Name of Proposed Subdivision LAKE RIDGE PARK - BOTO ADDITION

**DRAINAGE AREA MAP**  
LAKE RIDGE PARK - BOTO ADDITION  
CITY OF ROCKWALL  
ROCKWALL COUNTY, TEXAS

Re: 1st Review  
Lake Ridge Park-Boto Addition

RE: Second Review  
Lake Ridge Park-Boto Addtn.  
ROK 84867

Rev. 11-16-84

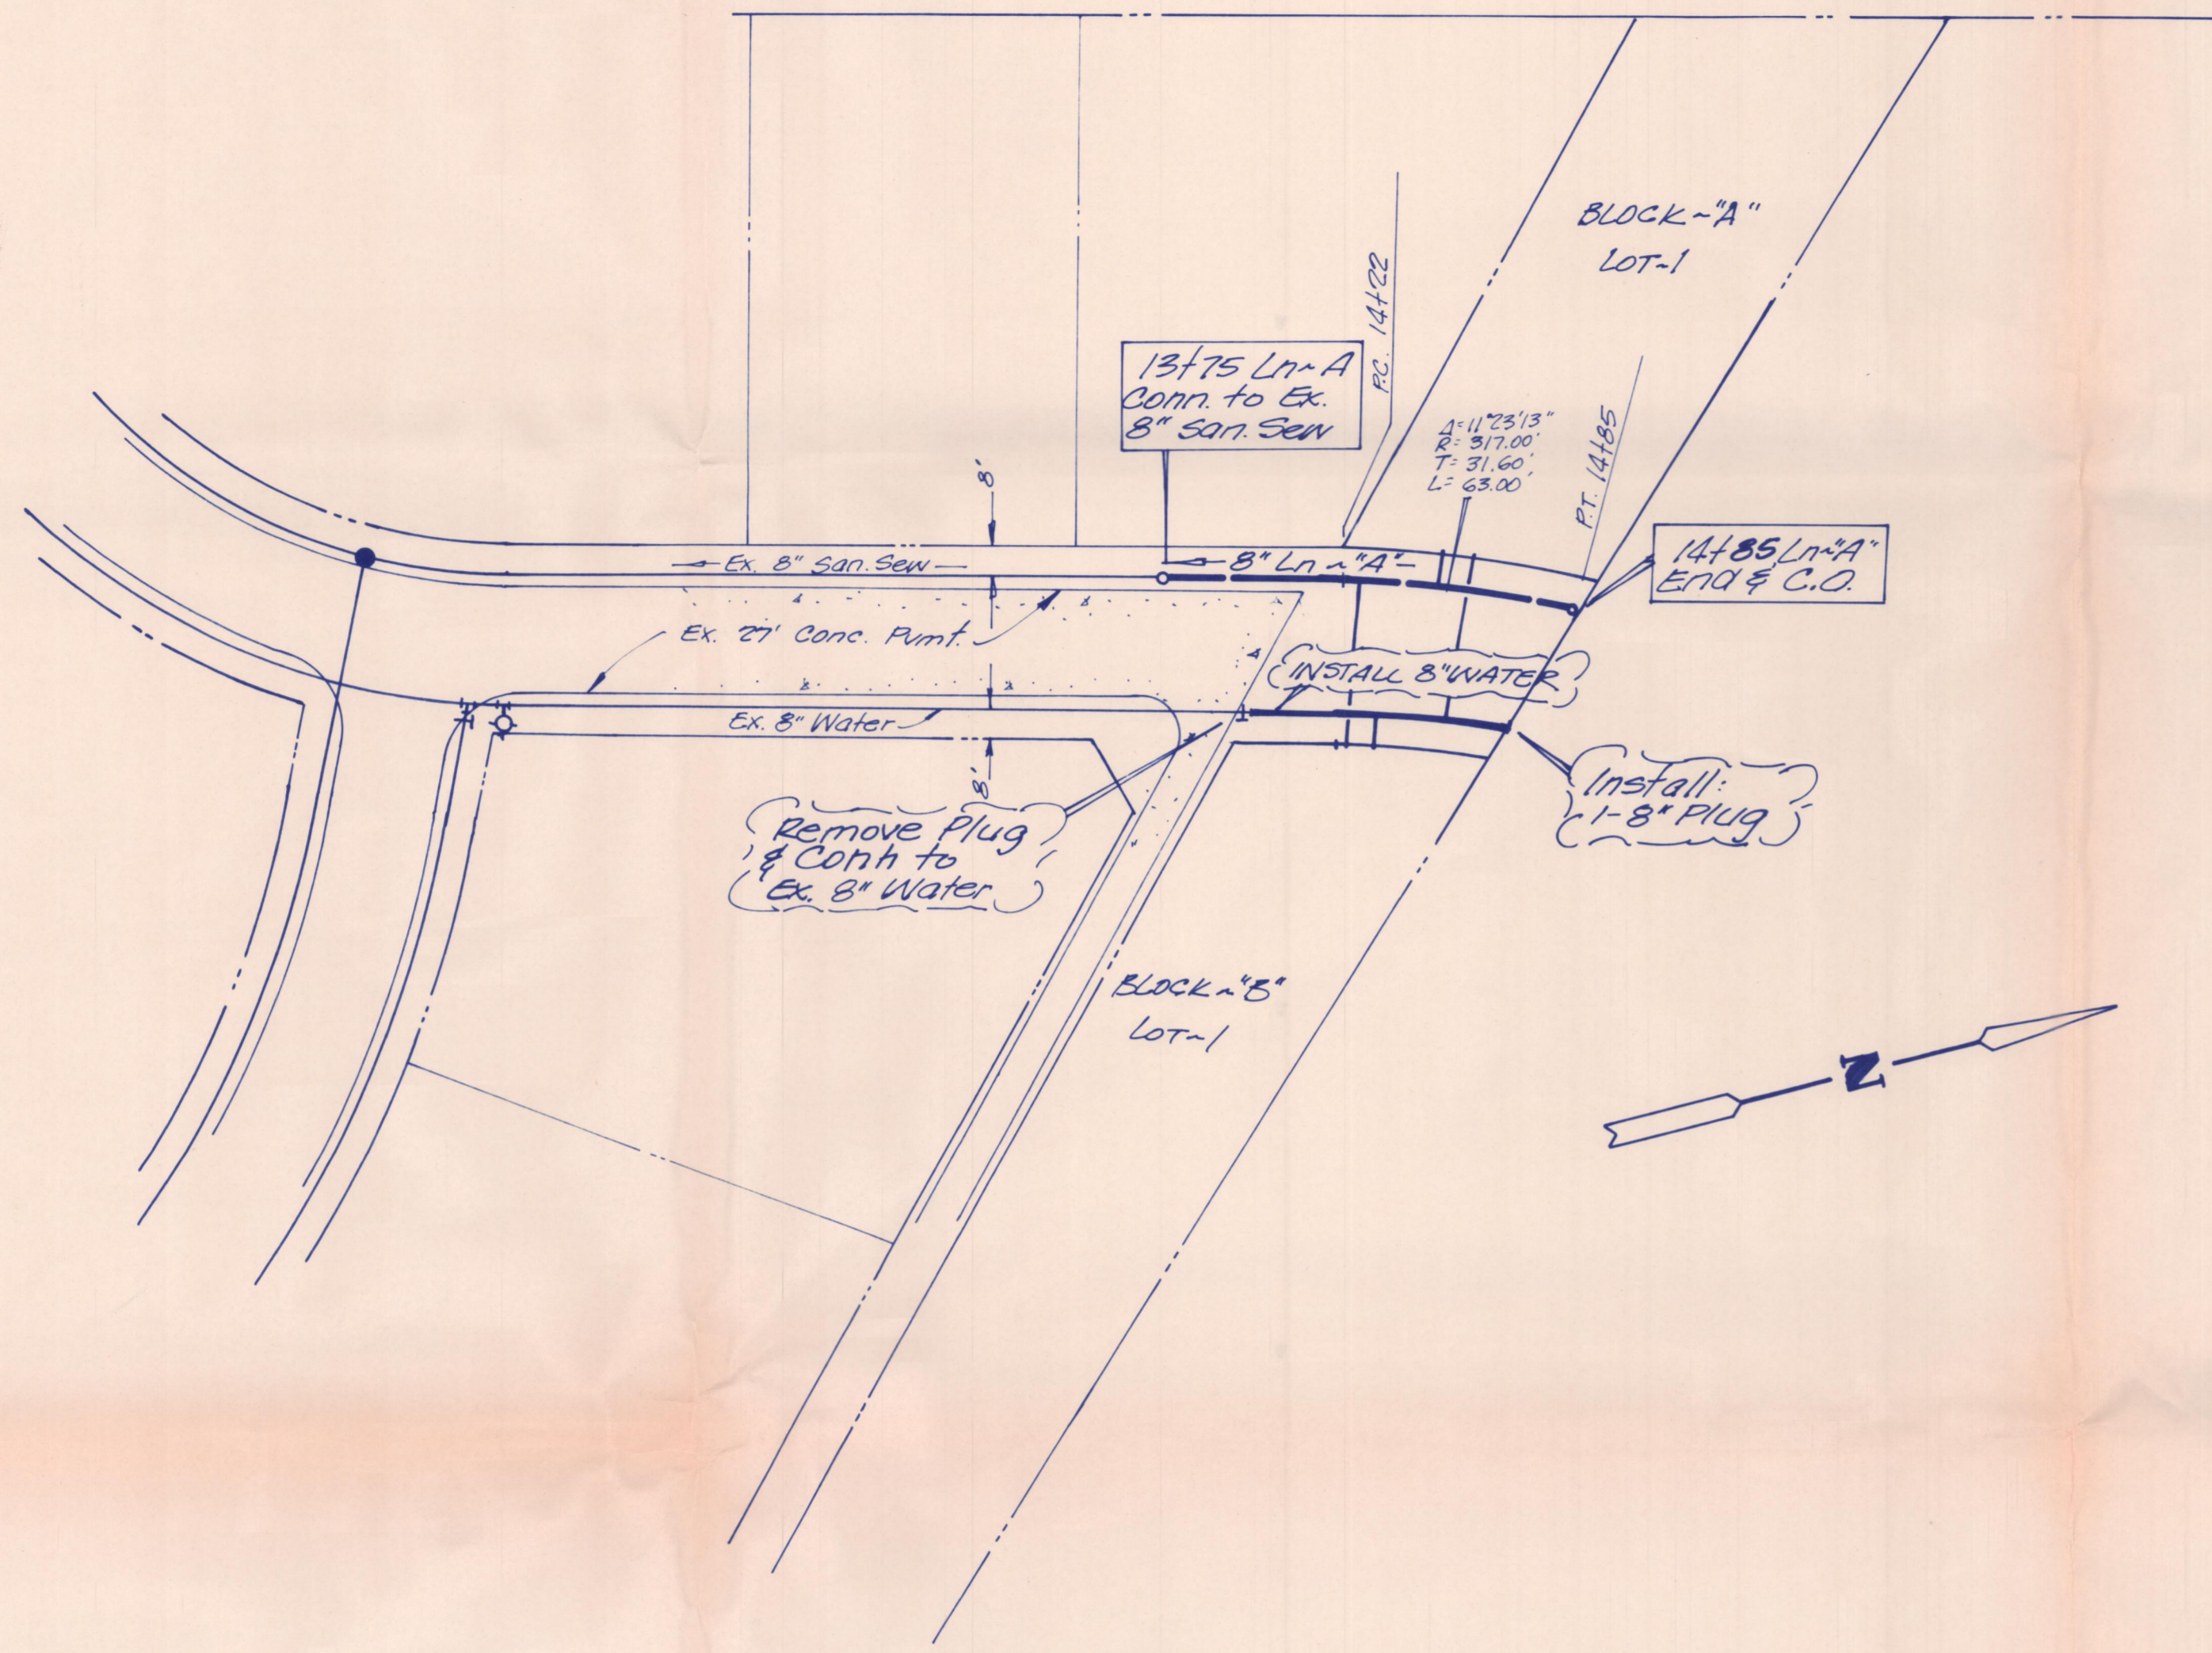
1. A general vicinity map should be provided.
2. The name of the street to be extended on the survey plat conflicts with the corresponding street name on the drainage area map.
3. The flow rate and direction of flow for Area 1 should be shown on the plan view. The size of the existing storm sewer should be indicated. Additional calculations should be provided in order to determine if the existing inlets and storm sewer can carry the additional flows without causing ponding of water during flooding conditions.
4. An inlet time of 15 minutes has been used for the drainage calculations. For the length of the streets proposed, an inlet time of 10-minutes and thus a rainfall intensity of 6.2 inches may be more appropriate.

The direction of flow for Area 1 has been provided as shown on the plan view. The storm drainage calculations have been provided as requested. However, the size of the existing storm sewer has not yet been indicated. We recommend that the Developer research the designed capacity of the existing storm sewer and inlets to determine if the discharges can be carried.

The other comments in the first review have been addressed. Although the northern drainage boundary has been altered from those proposed in the first set of plans due to future development, the information provided appears to be sufficient. If the future development is not completed, the drainage area contributing to the existing storm sewer will be greater.

ALL ITEMS IN LETTER DATED OCT. 22, 1984  
HAVE BEEN ANSWERED PER COMMENTS  
MADE BY CITY ENGINEER
